ADA Curb Ramp New Construction Inspection Form (Parallel)

NW Curtis St

23885.56

NW Highland Ct

PARALLEL RAMP (PL)

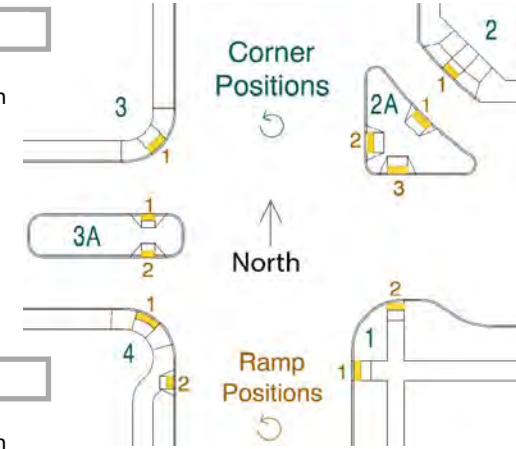
2.7 $\leq 2.0\%$ ☐ $> 2.0\%$ ☒

2.1 $\leq 2.0\%$ ☐ $> 2.0\%$ ☒

7.3 $\leq |5.0\%|$ ☐ $> |5.0\%|$ ☒

2.7 $\leq 2.0\%$ ☐ $> 2.0\%$ ☒

2.1 $\leq 2.0\%$ ☐ $> 2.0\%$ ☒
